TO: Development Review Board
FROM: Scott Gustin
DATE: October 1, 2013
RE: 14-0291CA; 135 University Road

Request: Convert existing soccer bleachers to partially enclosed structure, install roof over entire remaining structure, enclose easterly portion for storage, and pave asphalt entry area

CENTENNIAL STORAGE FACILITY
UNIVERSITY OF VERMONT
Burlington, VT

PROPOSED ELEVATIONS

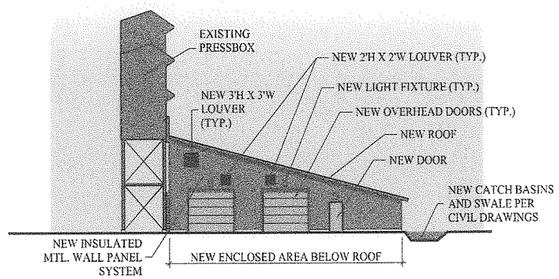
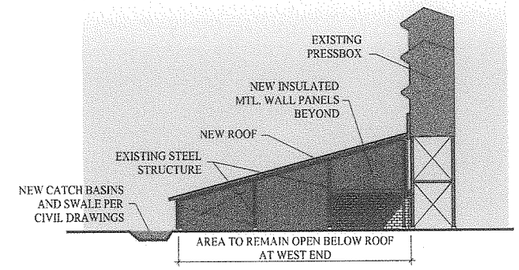
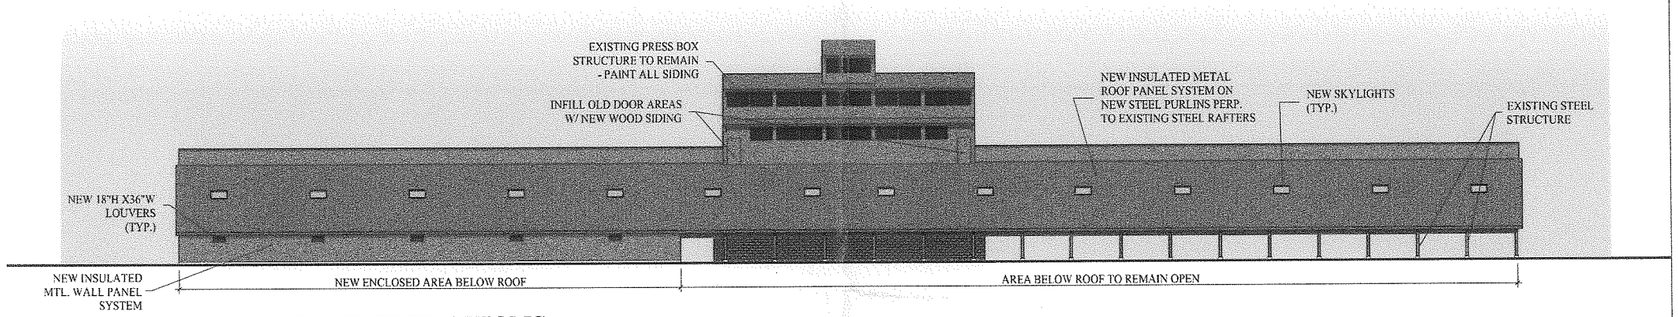
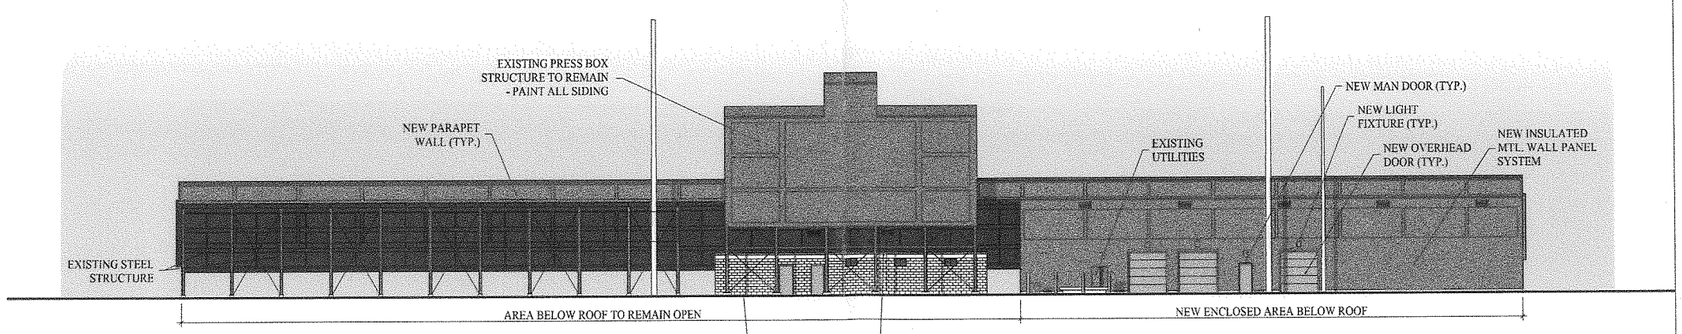
Sec. 5.5.2, Outdoor Lighting
New lighting fixtures will be installed over the doorways. The fixture locations are indicated on the elevation plans. They are acceptable cutoff LED fixtures generating 1,401 lumens.
(Affirmative finding)
